RECEIPT DATE: 11/9/23 **ONSITE SEWAGE DISPOSAL SYSTEM** P 575696

APPROVAL DATE: 12/12/23 **PERMIT: UPGRADE (TANK ONLY)** A \_\_\_\_\_

PROPERTY ADDRESS: 12525 Marlow Road

SUBDIVISION: Hickory Hills Farm LOT: 4 TAX ID: \_\_\_\_\_

**SITE PLAN**

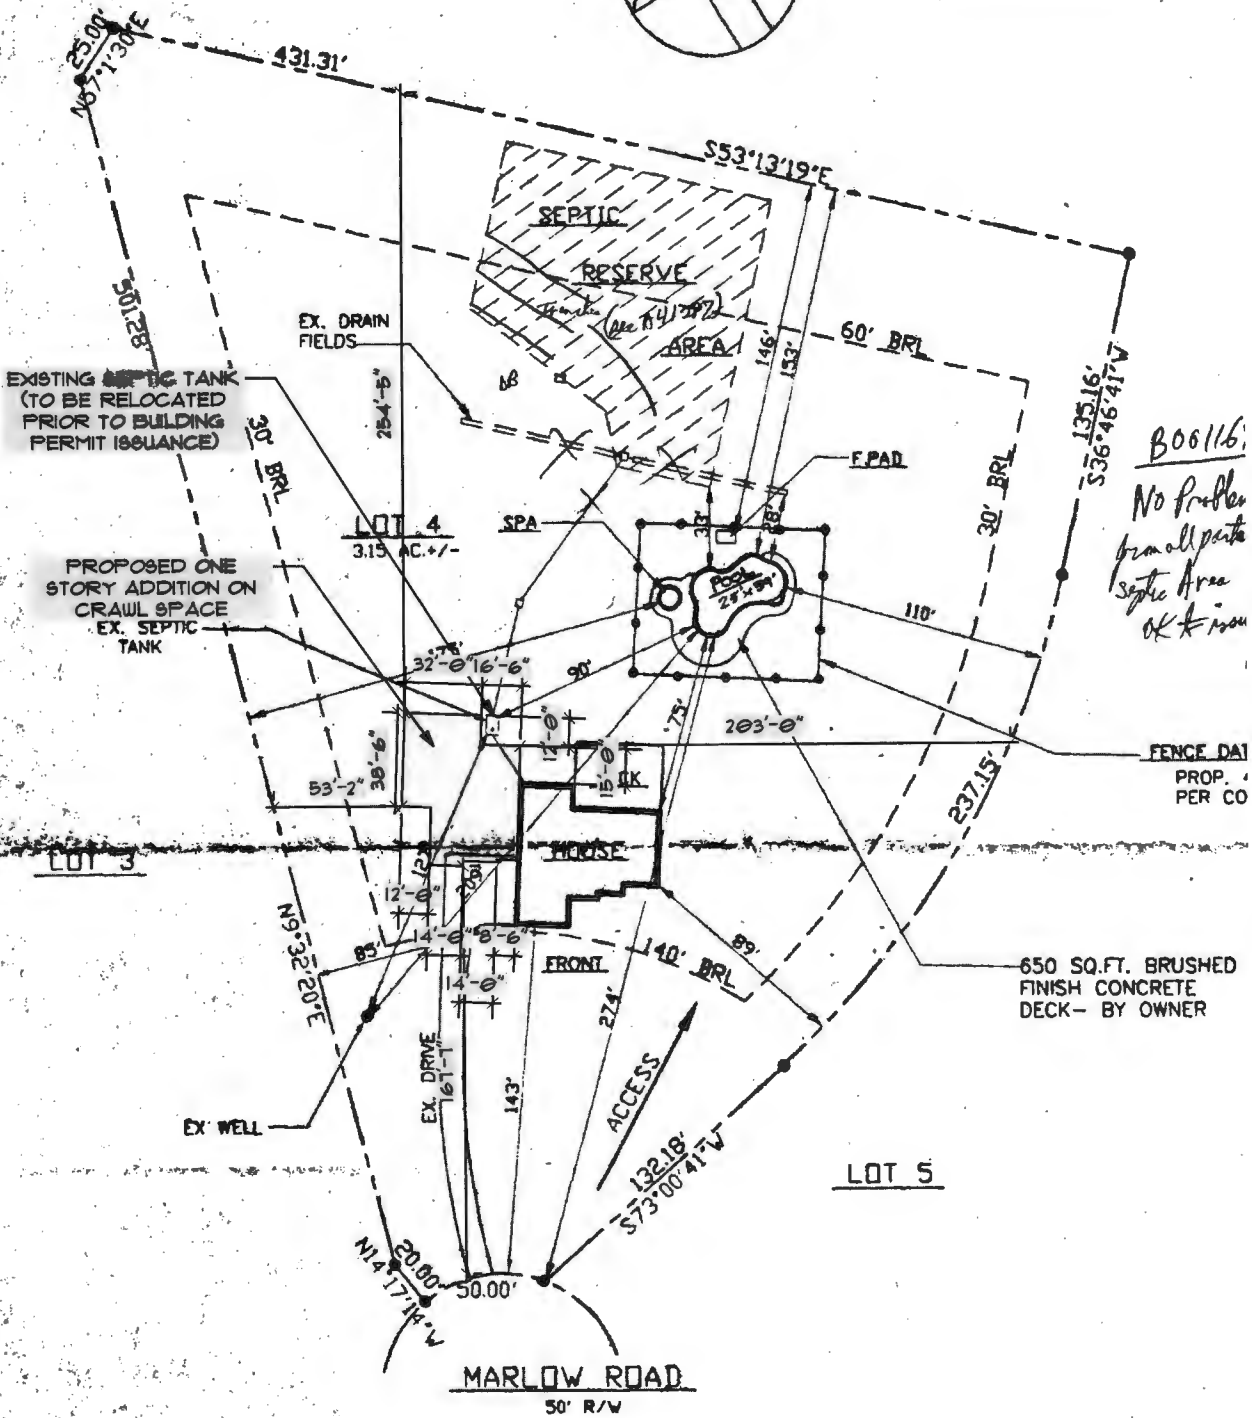
*B06116:  
No problem  
from all parts  
Septic Area  
OK to issue*

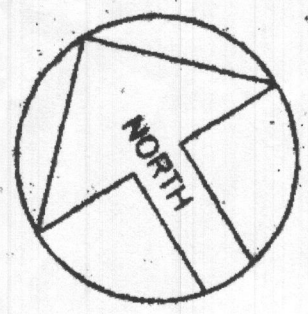
<u>Well</u>	<u>PC</u>	<u>OSDS</u>
- HO-81-2779	- Have Approved	- 1250 gal ST (4 BRs)
• casing 51	PC w/ corresponding	- 280' (4x70' Trenches)
• Depth 165	perc notes.	- 4.5' - 6.5' Trench Depth
- In Baltimore	- A, B, 1 Specs	- See Back of spec
Oniess	- Property not	Sheet for trench
- HO-95-2033 (Geo)	in wetseason	calculations.
	soils	(7 BRs Max Based
		on records for
		Trenches

- Ex. Well Radium Testing Req
- Potability Testing, Mostly Bacteria + Nitrates due to 12519 Marlow Septic Upgrade.
- Septic Tank Upgrade if more than 4 BRs
- OSDS showing 2 replacement systems? Per Jeff Williams does not need to prove 2 replacements fit if adding only 1 or 2 bedrooms.

**SITE PLAN**  
SCALE: 1" = 50'

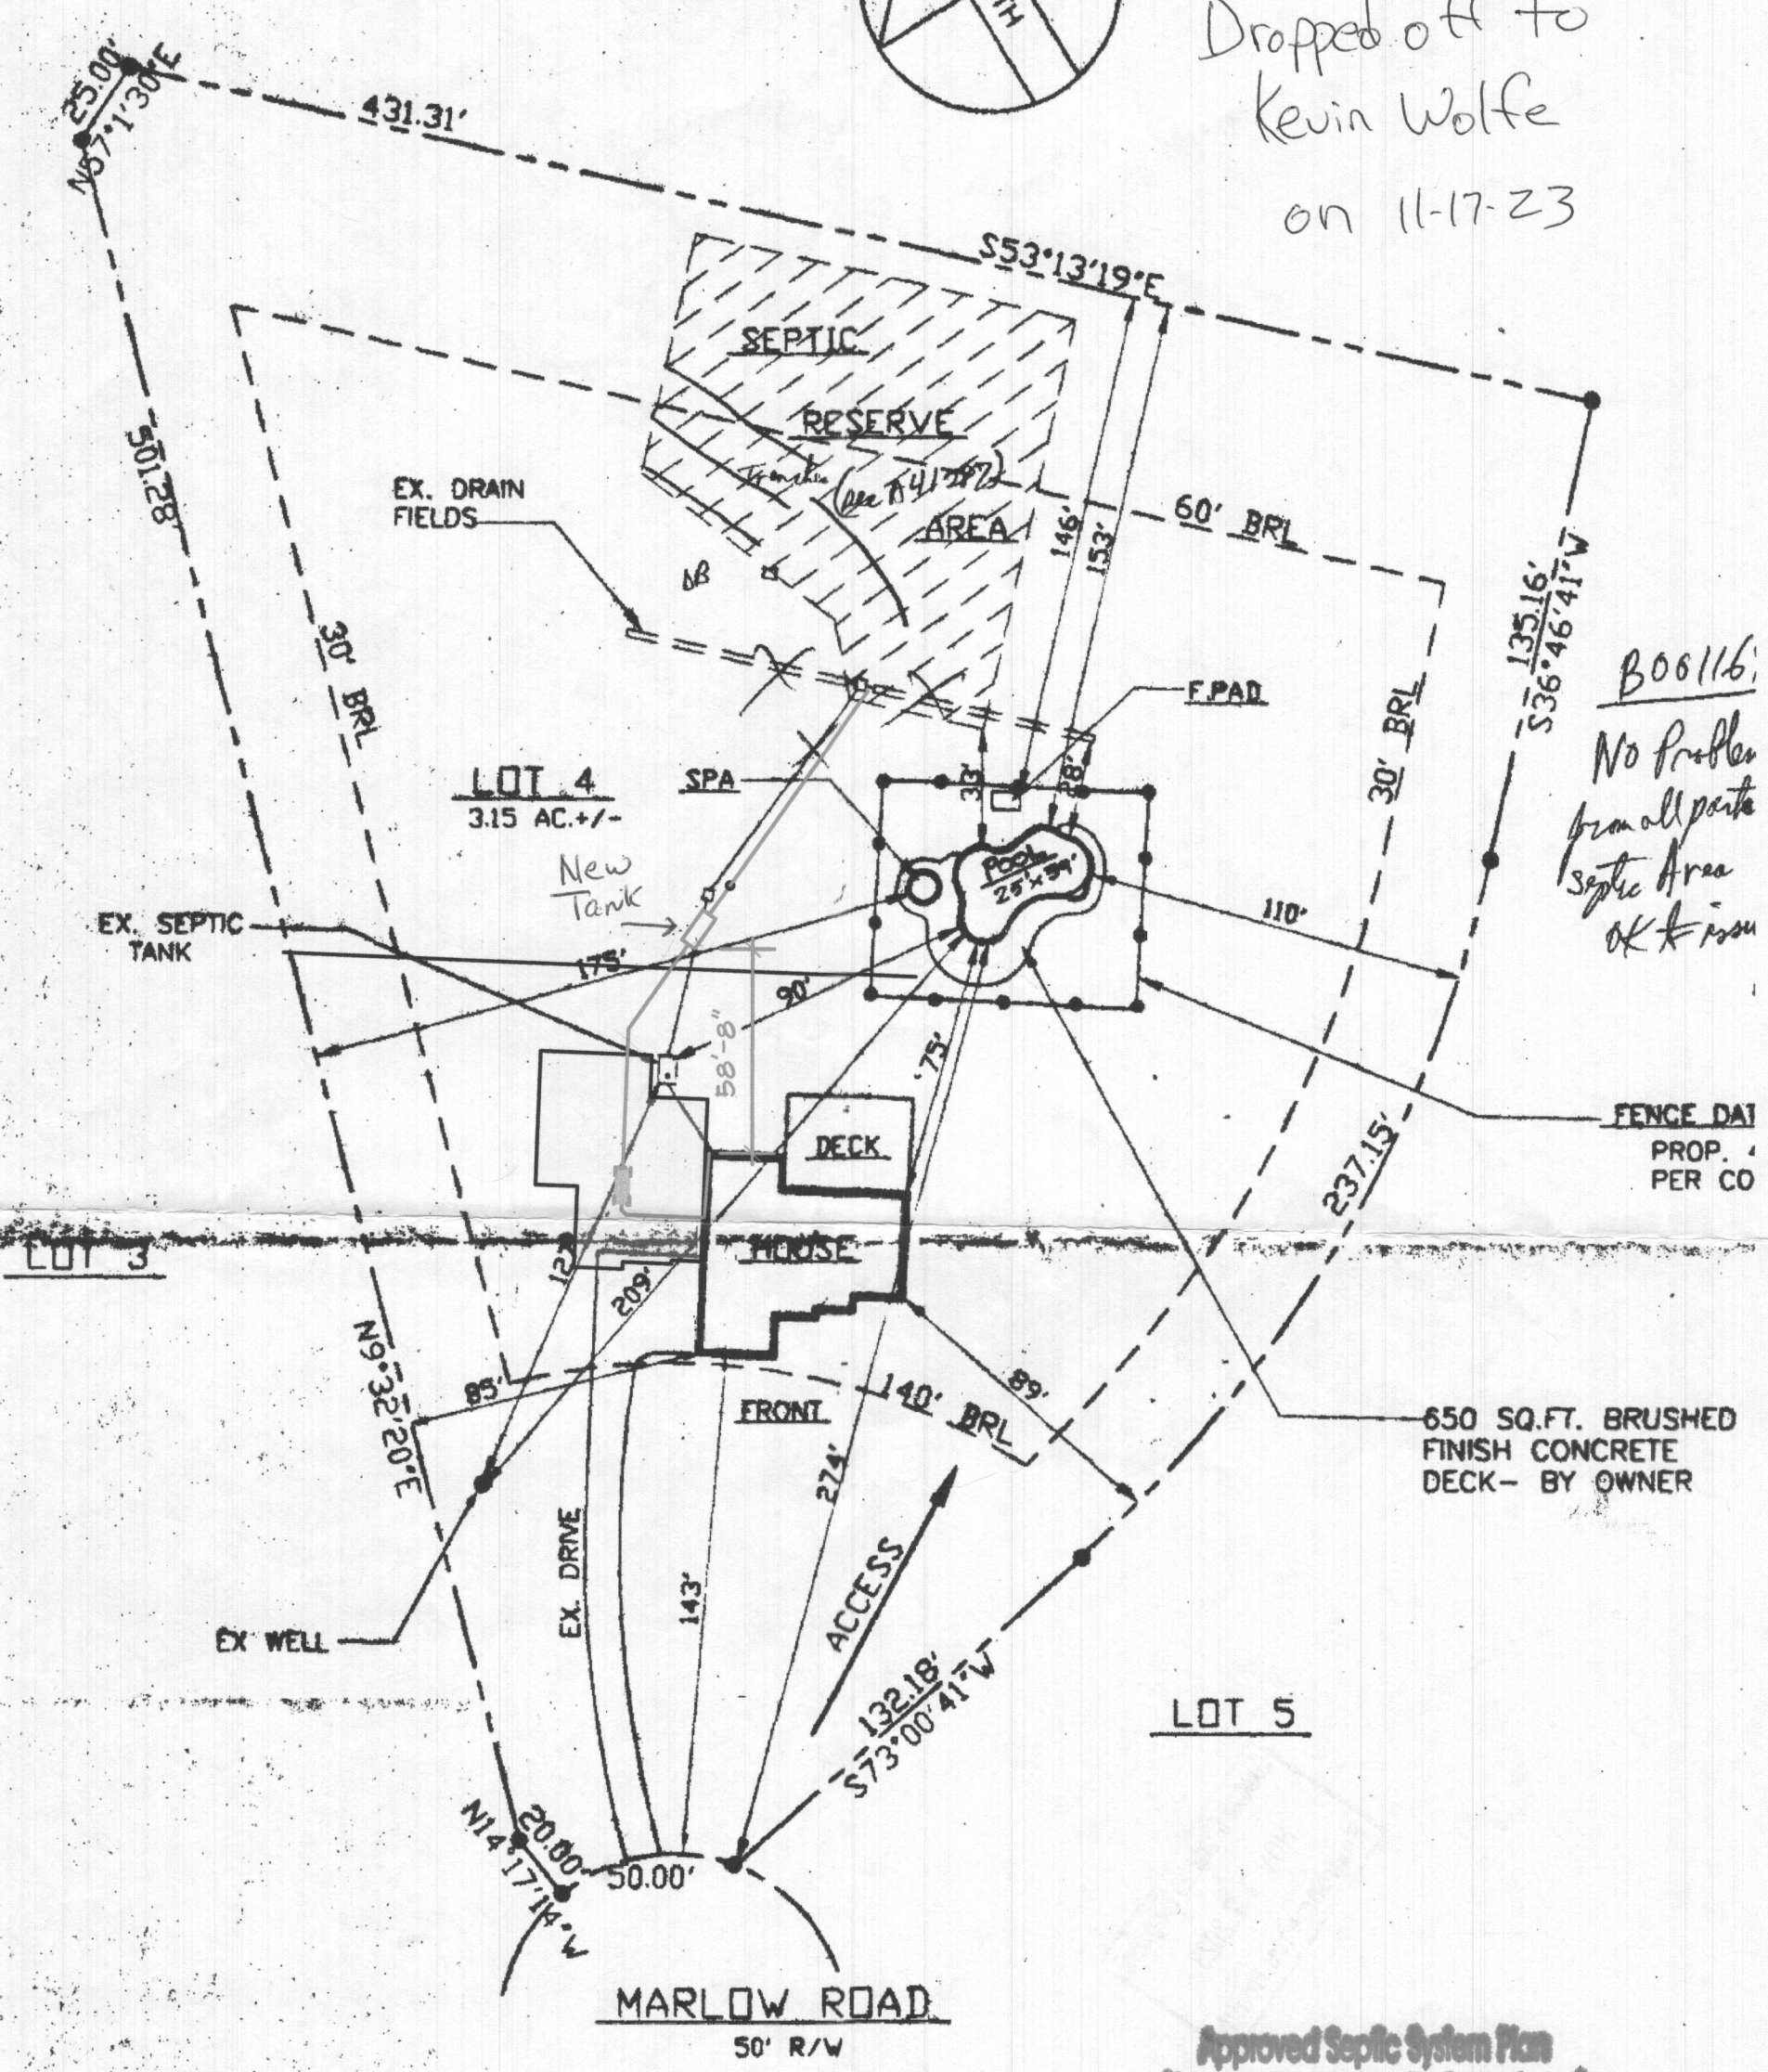
*B00116:  
No problem  
from all parts  
Septic Area  
OK for issue*

**Approved Septic System Plan  
Howard County Health Department**  
*[Signature]* 12/11/2023  
Signature Date
